AGENDA
PLANNING AND ZONING COMMISSION MEETING
CITY OF CREVE COEUR, MISSOURI
MONDAY, AUGUST 15, 2022
6:00 PM

UNFINISHED BUSINESS**1. Application #22-012: Minor Site Plan for Four Electric Vehicle Charging Stations and Accompanying Equipment Located Within Plaza Shops at 745 North New Ballas Road**

Subject: **EV Go's Response to the Planning and Zoning Commission's Requests
Application #22-014**

**APPLICATION TO PLANNING AND ZONING COMMISSION
#22-012: MINOR SITE PLAN FOUR ELECTRIC VEHICLE CHARGING
STATIONS AND ACCOMPANYING EQUIPMENT LOCATED WITHIN
PLAZA SHOPS AT 745 NORTH NEW BALLAS ROAD**

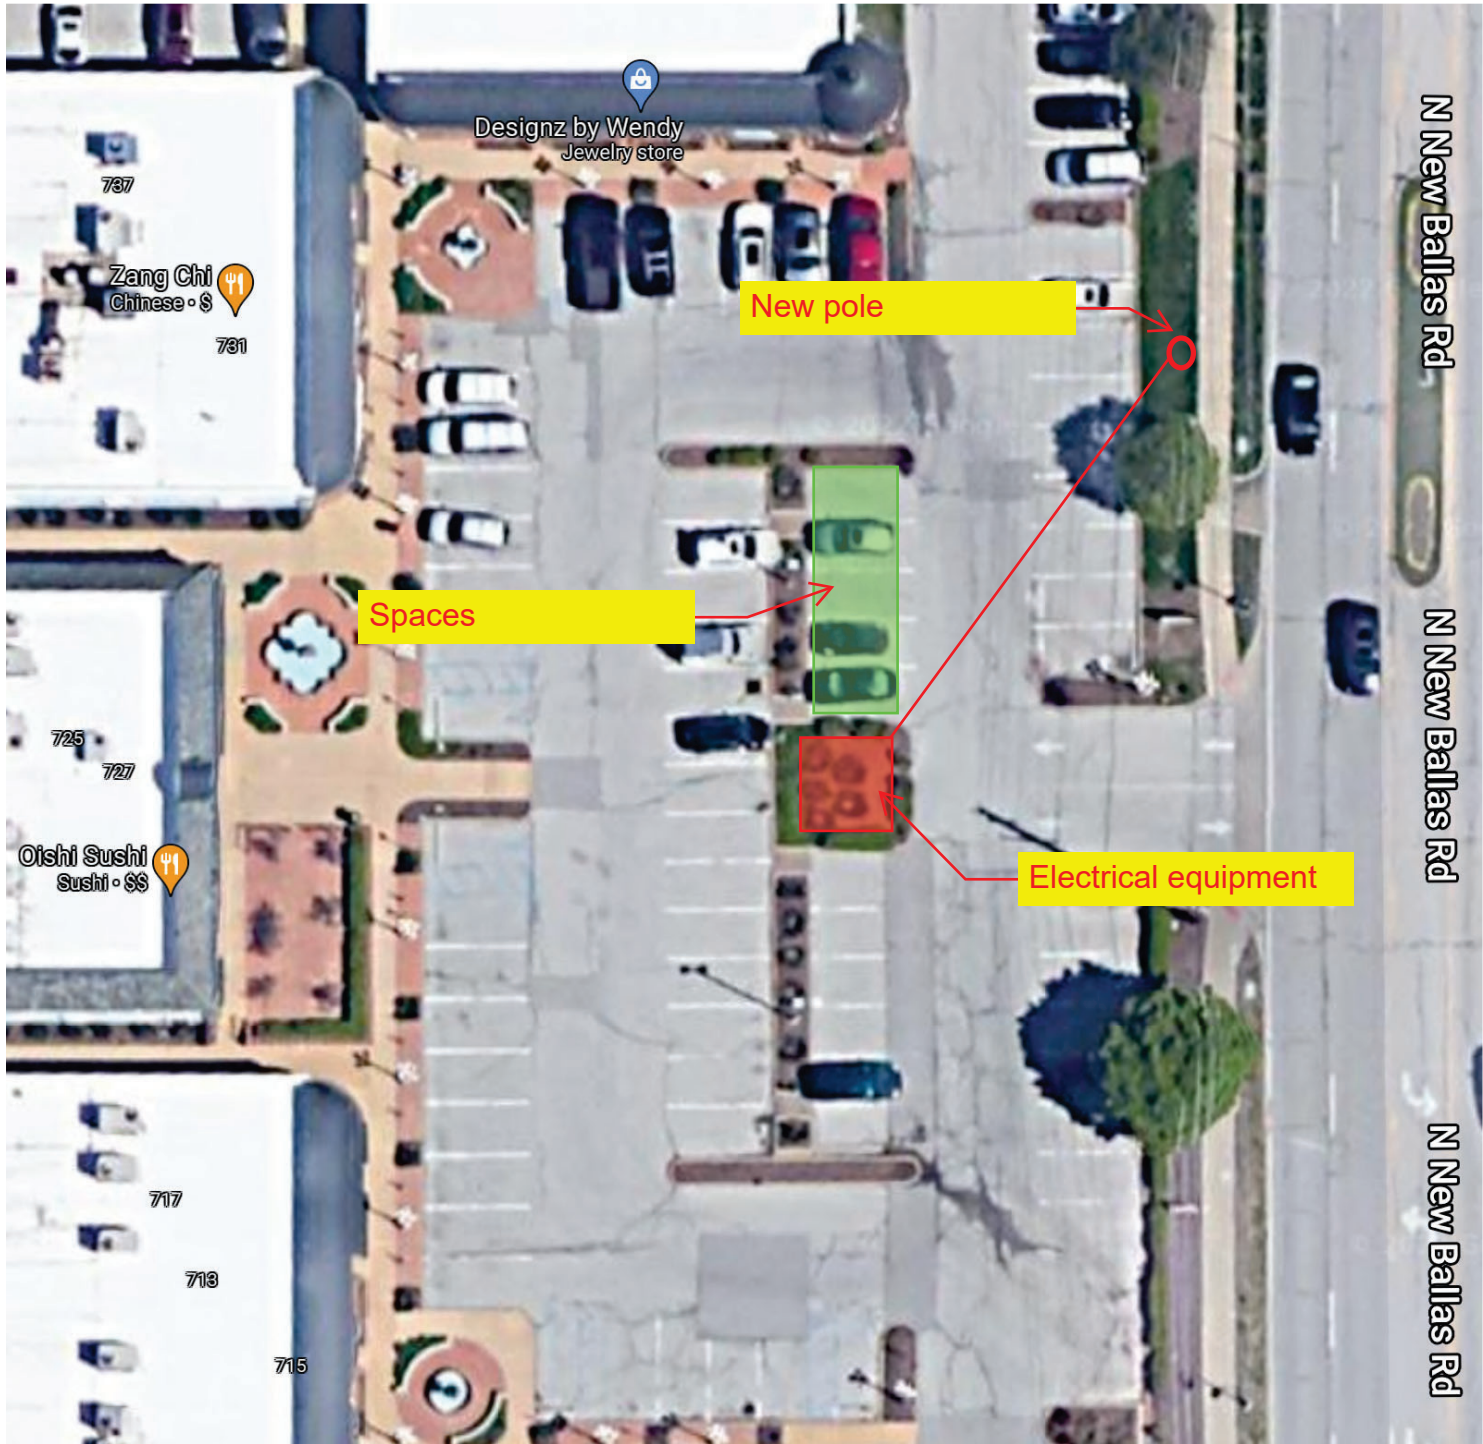
After reviewing the submitted revisions and additional information, staff still has concerns about the location of the charging station equipment within a landscaped area directly in front of the entrance to the shopping center. The landscape plan shows upright evergreens to help screen the units, however this landscaping is minimal and not comparable to the existing landscaping within this area. It would be less of a concern is there was larger space to accommodate additional plant material, given the prominent location on the site.

No explanation was given to justify the current location as opposed to the specific location recommended by staff along the side of the building adjacent to Sauce on the Side. This location would allow for more screening of the equipment, would be less intrusive to the site and less visually impactful when viewed from the street. With respect to parking, this location would require removal of spaces closer to the storefronts, however, the parking lot is small, and the center has a surplus of parking to meet the City’s minimum requirements.

According to the documents for site coverage provided by EV Go, the existing site coverage is at 65%, 2% over the allowed 63% site coverage for the CB District, but below the maximum 70% allowed with approval of a site coverage bonus by the Commission. The proposed project would bring the total site coverage up to 65.14%. The Planning and Zoning Commission may, in its discretion, allow the permitted coverage to be increased as a bonus not to exceed the total 70% site coverage in consideration of special or outstanding landscape and site planning features as demonstrated by a site development plan submitted in accordance with Section **405.1080**. The features to be considered in the granting of any bonus coverage may include, but not be limited to, the provision of:

No mitigating factors for the 0.14% increase to the existing site coverage are proposed and the landscaping that is shown to screen the equipment is reduced compared to existing. While the increase is very minimal, the discretion is vested with the Planning and Zoning Commission in consideration of any site coverage bonus.

The Planning and Zoning Commission should consider the location and visibility of the charging stations and equipment, as well as the potential impacts on future similar projects, when reviewing the proposal. If further mitigation is necessary in the form of additional landscaping or other considerations to justify an additional increase in site coverage the Commission should provide direction for the applicant. The Commission should also gain a better understanding from the applicant of why other locations are not possible. Alternatively, if the constraints of the site and the chosen placement are not appropriate, the Commission should consider denial of the request, as submitted.
